Recall Bulletin

PRODUCT SAFETY RECALL

SUBJECT: Front Axle Right Half Shaft Fracture

MODELS: 2013-2014 Chevrolet Cruze
Equipped with 1.4L Turbo Engine (LUV)

3802759

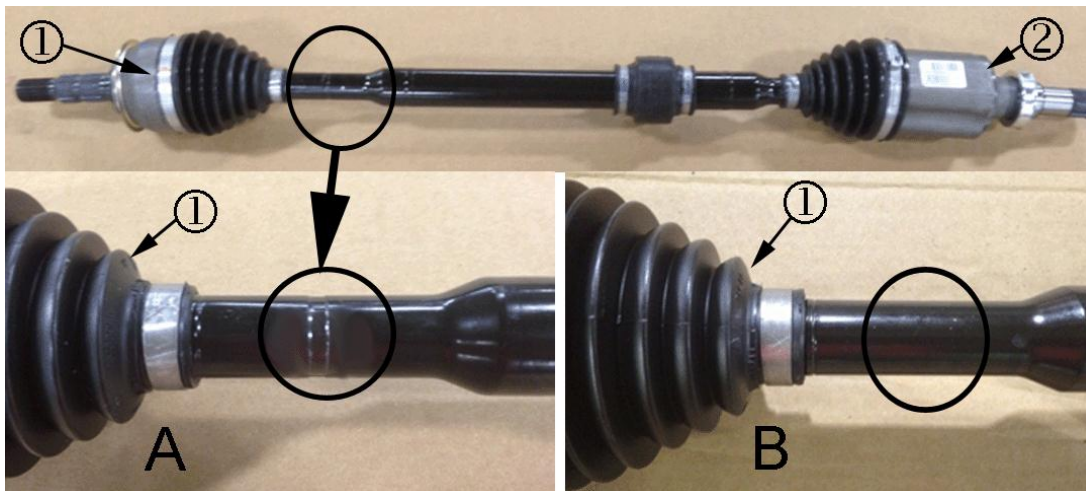
1. Inspect the inboard side of the shaft (shorter portion between rubber isolator and boot) for a green stripe, green dot or combination of green stripe and green dot.
 - If these markings are present, this is a good part.

- If there are no green markings on the inboard portion of the shaft (4) this part should be returned to General Motors under special return message G_0000187857 dated March 18, 2014 (US) or GMP 2014-073 dated March 17, 2014 (CN).

3773590

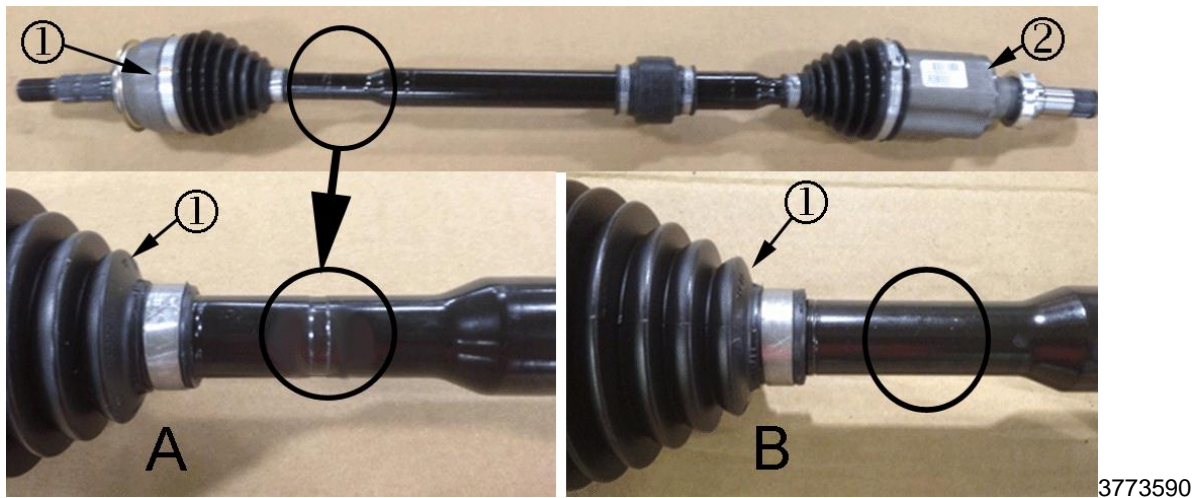
1. Inspect outboard side of the half shaft (longer portion of shaft between CV joint and isolator). Determine if a machined groove is present on the half shaft.
 - If the machined groove is present (A) on the half shaft, the part can be used for service.
 - If the machined groove is NOT present (B) on the half shaft, proceed to step 2.

2. Inspect the inboard side of the shaft (shorter portion between rubber isolator and boot) for a green stripe, green dot or combination of green stripe and green dot.
 - If these markings are present, this part can be used for service.
 - If no green strip, green dot, or green stripe and dot is present, this part should be returned to General Motors under special return message G_0000187857 dated March 18, 2014 (US) or GMP 2014-073 dated March 17, 2014 (CN).

(1) Wheel Side of Half Shaft (2) Transmission Side of Half Shaft (A) Machined Groove (B) No Groove

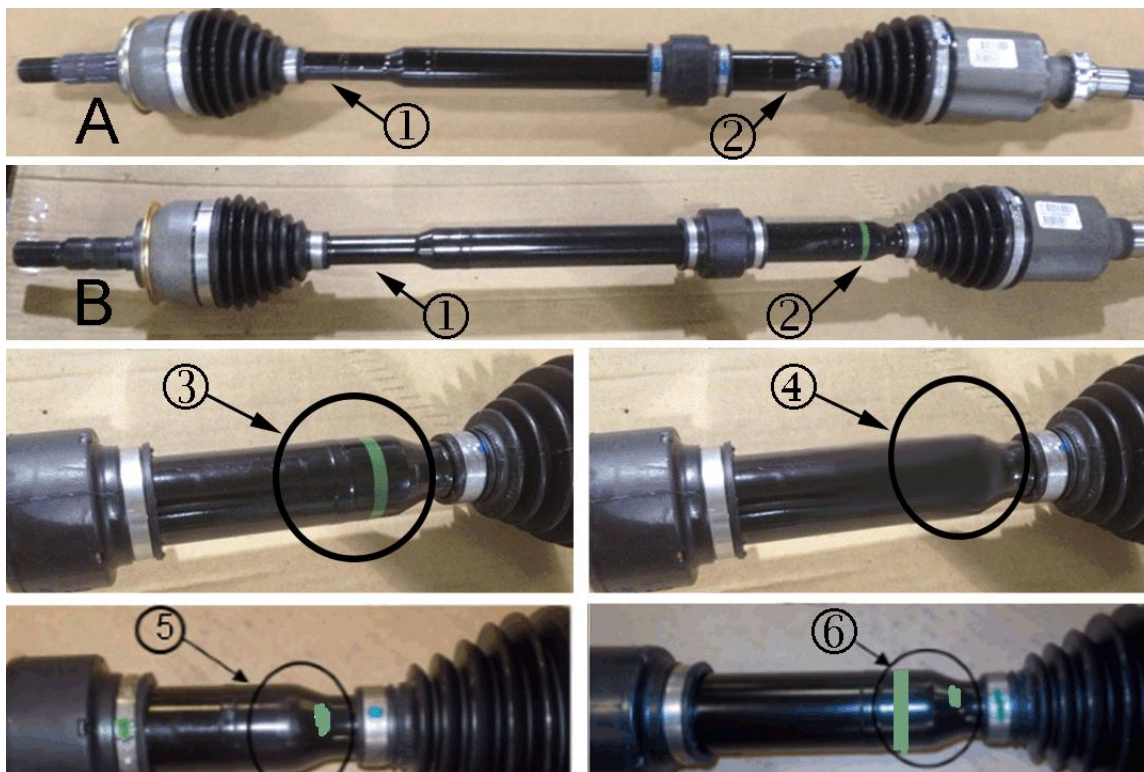
1. Raise and support the vehicle. Refer to *Lifting and Jacking the Vehicle* in SI.
2. Inspect the right (passenger side) half shaft near the front wheel. Determine if a machined groove is present on the half shaft.

- If the machined groove is present (A) on the half shaft, no further action is required. Lower the vehicle.
 - If the machined groove is NOT present (B) on the half shaft, proceed to step 3.
3. Inspect the right (passenger side) half shaft near the transmission. Determine if a green stripe, green dot, or green stripe and green dot is present on the half shaft bar.
